To: D. Thompson
From: D. Sheppard
Re: GLAST LAT ACD FREE Electronics Problem Report ACD-0-001
Date: 2-11-2004
Cc: R. Baker, J. Odom, M. Smith, G. Unger, G. Haller

Summary:

On 1/15/04, a Problem Report was written against the ACD electronics. This references a problem with uninitialized flip-flops in the GARC V3 ASIC. A solution is proposed that involves wire-Oring the clock and reset signals on the FREE printed circuit board and adding terminations resistors on the DAQ side of the interface.

Present Circuit

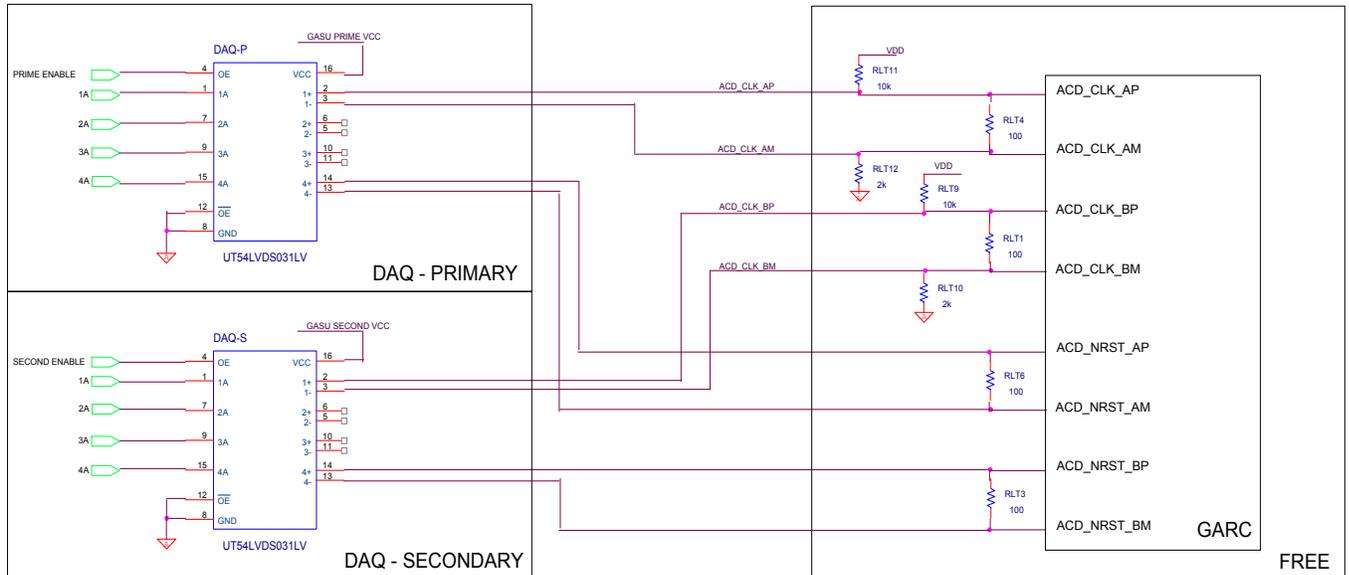
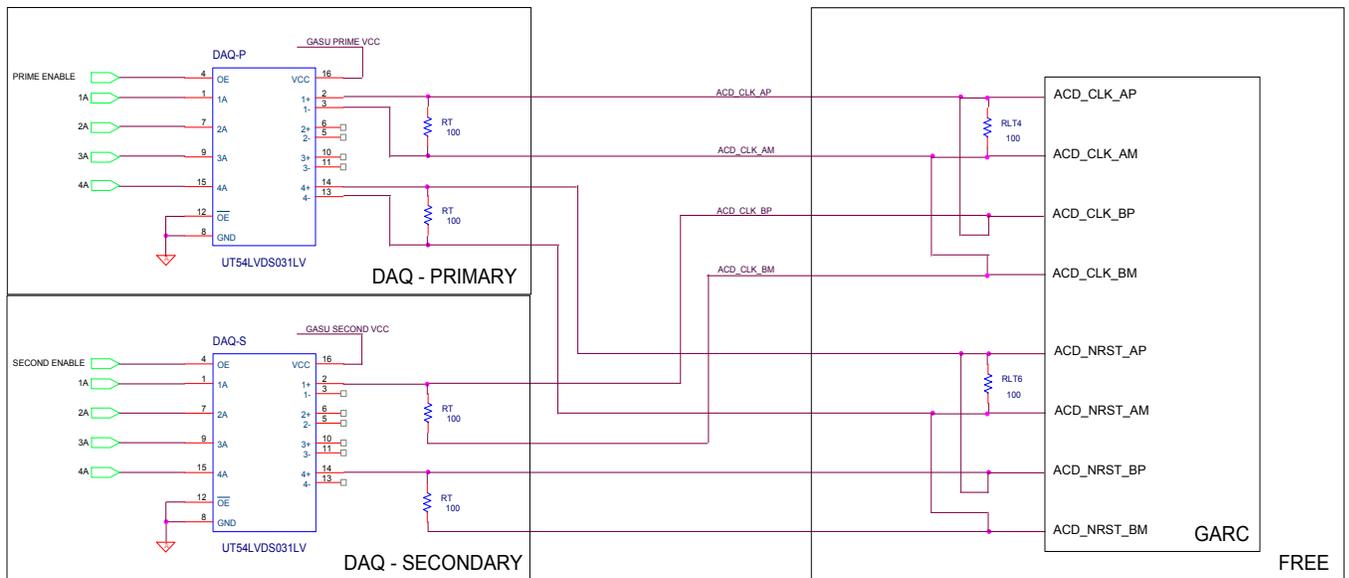
Solution 3: This would be a fix involving wire-ORing the primary and redundant driver circuits. This would involve changing from the present circuit, which is shown in the schematic below,

to the proposed circuit shown at the bottom of the page. This involves removing termination resistors on the FREE board and adding termination resistors on the DAQ interface board, as drawn.

The modifications to the FREE card involve the following:

1. Removing secondary side termination resistor RLT1
2. Wire ACD_CLK_BP to ACD_CLK_AP on the FREE card with a 30 gauge wire. This is a short wire of less than one inch.
3. Similarly, wire ACD_CLK_BM to ACD_CLK_AM on the FREE card with a 30 gauge wire. This is also a short wire of less than one inch.
4. Disconnect RLT11 from ACD_CLK_AP (removing the 10k pullup)
5. Disconnect RLT12 from ACD_CLK_AM (removing the 2k pulldown)
6. Disconnect RLT9 from ACD_CLK_BP (removing the 10k pullup)
7. Disconnect RLT10 from ACD_CLK_BM (removing the 2k pulldown)
8. Remove secondary side termination resistor RLT3
9. Wire ACD_NRST_BP to ACD_NRST_AP
10. Wire ACD_NRST_BM to ACD_NRST_AM

The modifications to each DAQ FREE card channel would be:

1. Add a termination resistor across the ACD_CLK_P and ACD_CLK_M signals.
2. Add a termination resistor across the ACD_NRST_P and ACD_NRST_M signals
